**Subject: Notice of Violation No. R9-2010-0135 and Water Code Section 13267
Technical Report, City of San Diego**

City of San Diego
Various Priority Development Projects

NOTICE OF VIOLATION No. R9-2010-0135

FACILITY INSPECTION REPORT

Figure 2. Bioswale 1

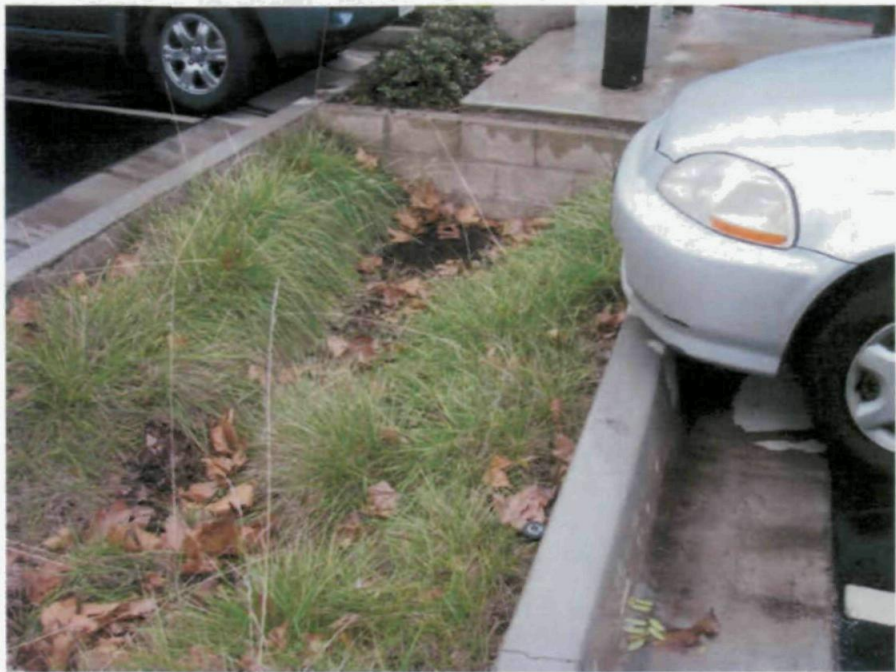
On January 20, 2010, Christina Arias inspected bioswales in a business park located at 3701 Ruffin Road. Figures 1-4 show the bioswales. Note there are no curb cuts, and subsequently runoff from the parking lot is not channeled into the bioswales. The engineering specifications available in the Water Quality Technical Report (WQTR; Figure 15) likewise do not indicate that runoff from the parking lot is intended to be channeled into the bioswales. The specifications include hatch marks near the bioswales, but it is not clear that these markings pertain to the intended flow of storm water. Storm water from the parking lot appears to leave the site with little to no treatment.

1. The City of San Diego should verify whether or not the bioswales at Highland Skypark (which do not treat polluted storm water) were designed or constructed incorrectly, or both.

Figure 12. Inlet for Bioswale 2

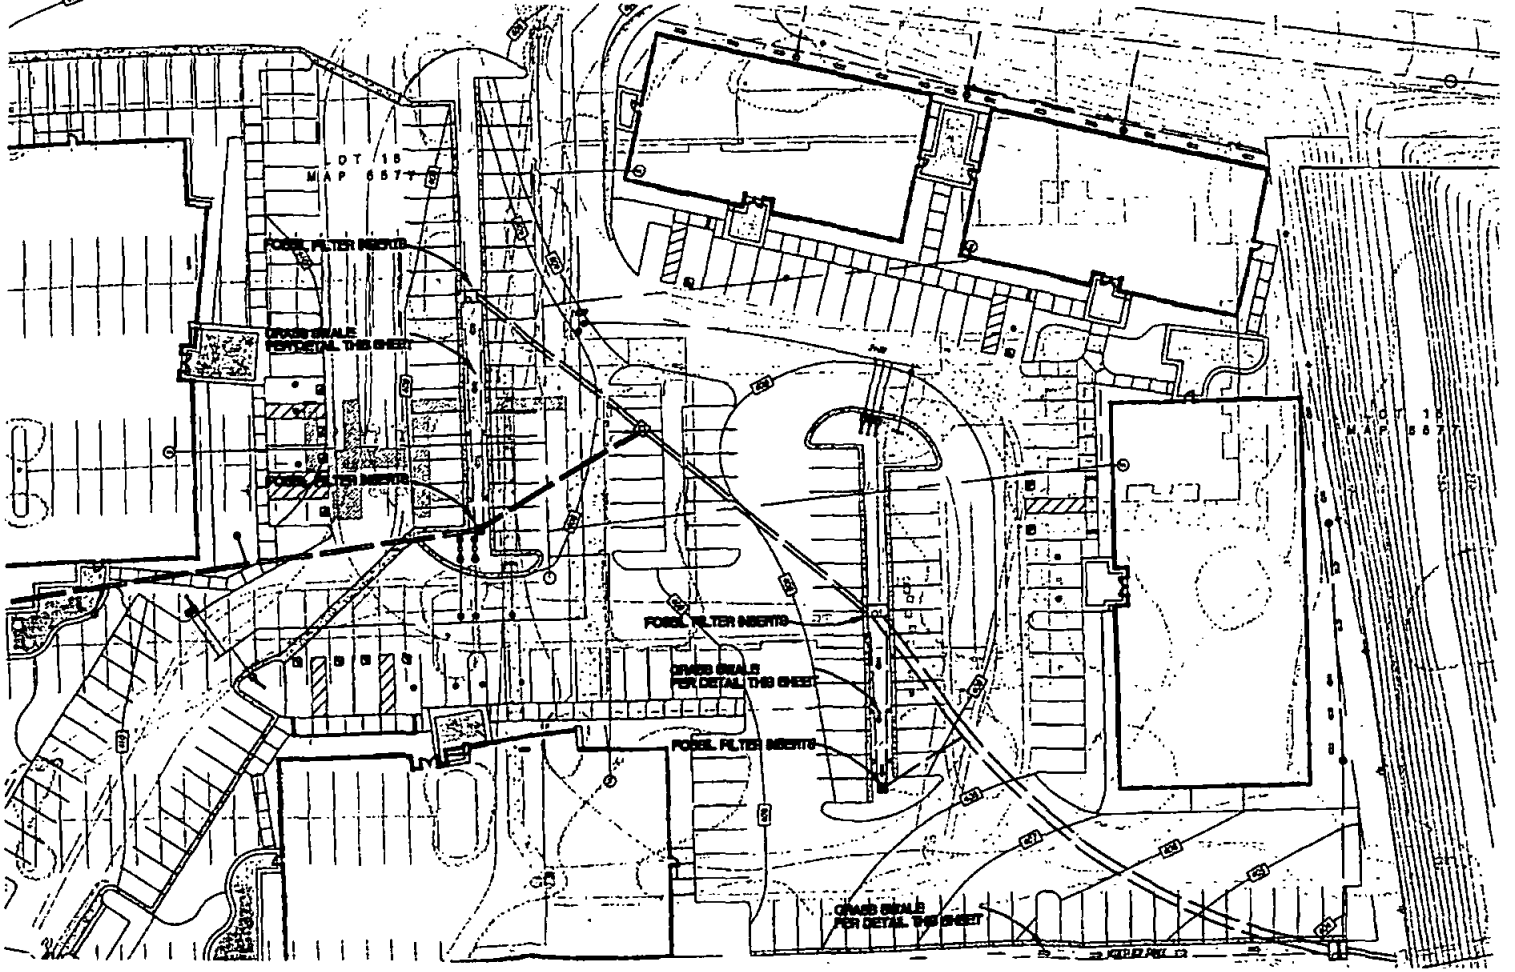
On April 9, 2010, Ben Neill and Christina Arias inspected two bioswales to treat runoff from the used car parking lot. The storm water runoff appeared to be untreated,

bypassing the bioswales (see Figures 9-14). Additionally, the bioswales did not appear to have the 3:1 side slopes or 4'-6" grass height recommended by CASQA. Engineering specifications and the WQTR for this location were not available.

2. The City of San Diego should verify that runoff from the parking lot at the Terraces at Copley Point receives treatment via the CDS unit.
3. The City of San Diego should locate the WQTR for Carmax Kearny Mesa and verify that the bioswales were constructed per the engineering specifications.

Figure 9. Looking upstream at vegetated swale (from storm drain)

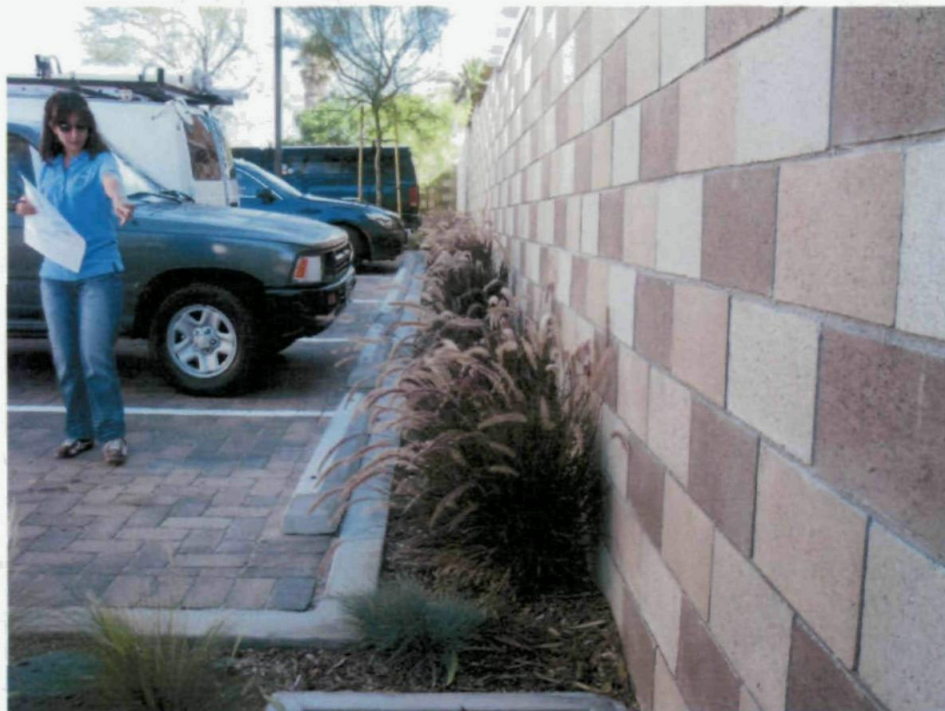
Runoff from parking lot either flows over pervious pavers or swale (behind wheel stop) before reaching storm drain

4. Because of the steep slope on the south side of the parking lot, the City of San Diego should verify that runoff generated from the 85th percentile storm event is adequately treated before being discharged offsite.

Figure 10. Roof drains at Rosecrans Commercial Center

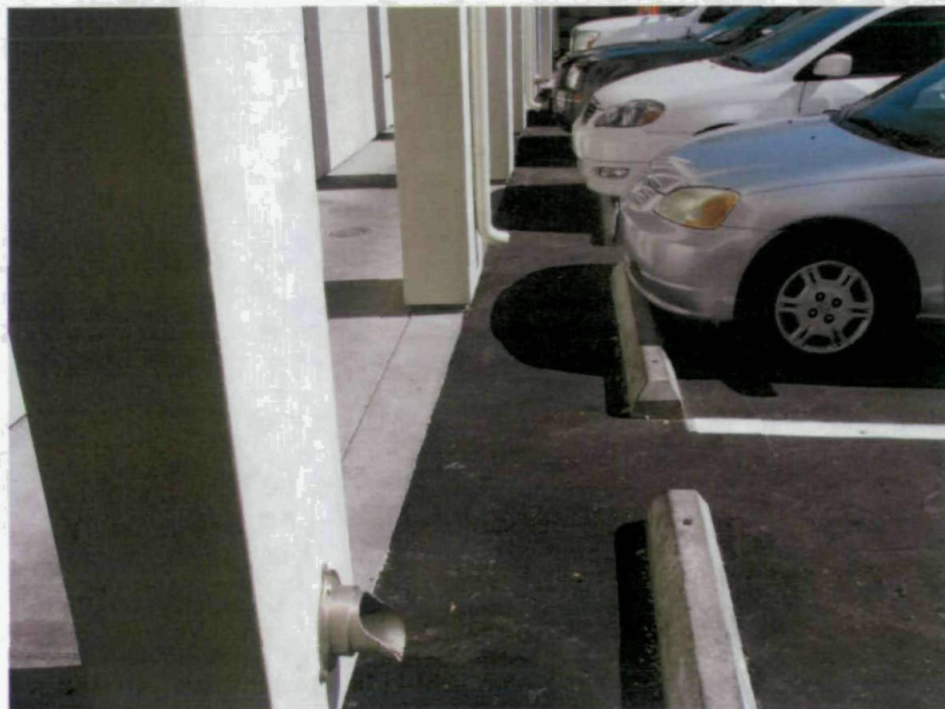
Rosecrans Commercial Center is in the Point Loma area of the City of San Diego and received final approval from the City in July 2009. Figures 8-13 show permanent BMPs installed in the parking lot. BMPs include porous pavers, a vegetated swale, and a trench drain with filter inserts (the swale is described as a bioswale in the engineering specifications and a grass swale on the BMP sheet). The storm drain shown in Figure 8 does not have an inlet filter. One roof drain discharges into a planter box; 3 roof drains discharge onto impervious asphalt.

Figure 11. Roof draining into planter box

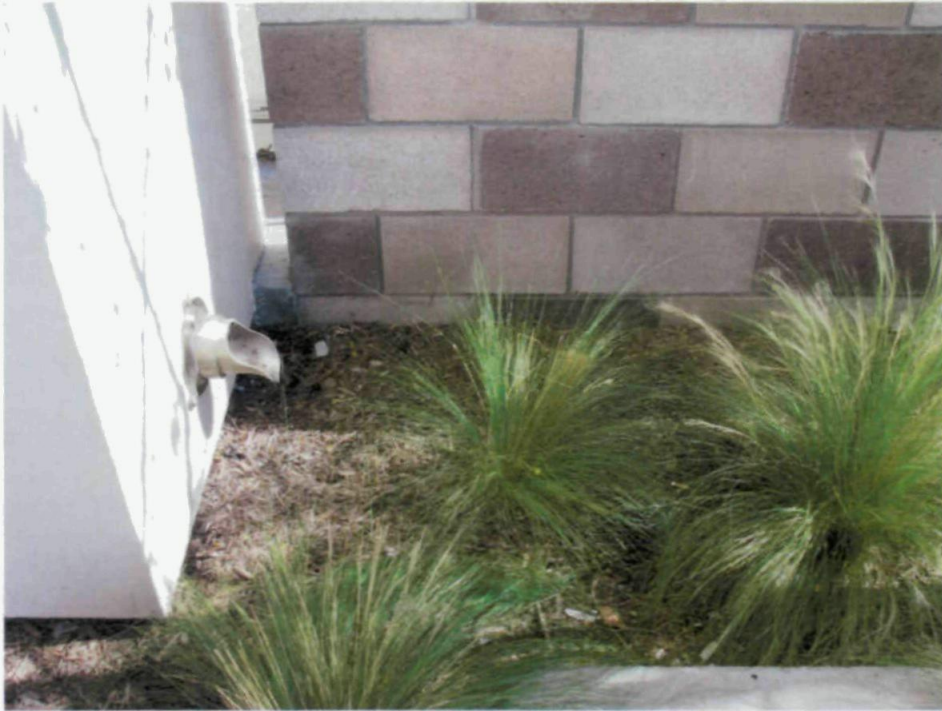
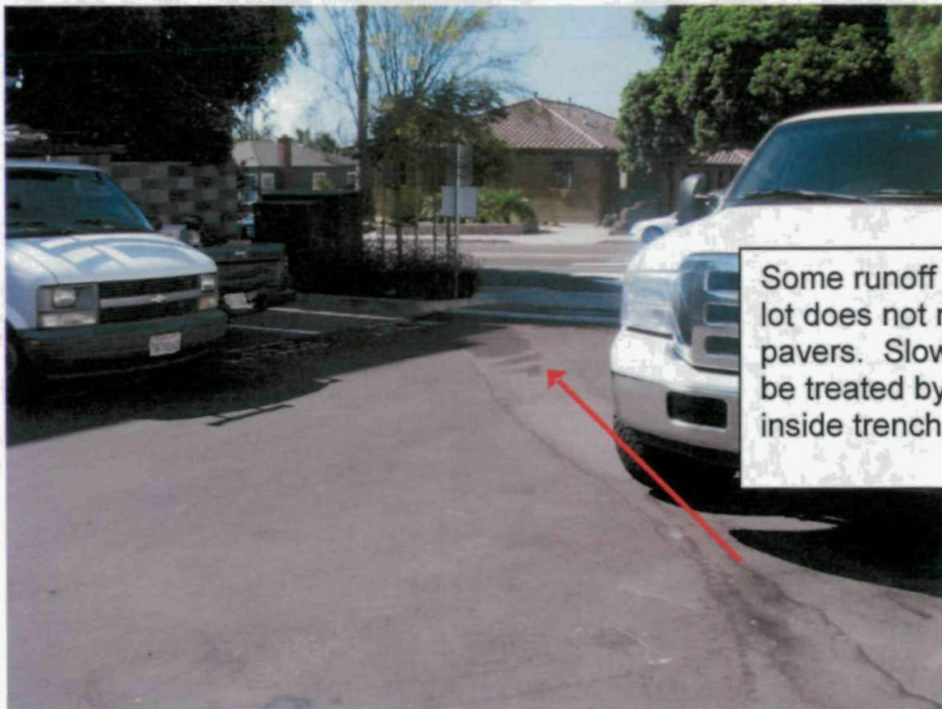
The south side of the parking lot has a 3.9 percent grade towards the street. Figure 12 shows water stains from the high point of the parking lot flowing towards the street.

Some runoff from parking lot does not reach pervious pavers. Slower flows may be treated by filter insert inside trench drain.
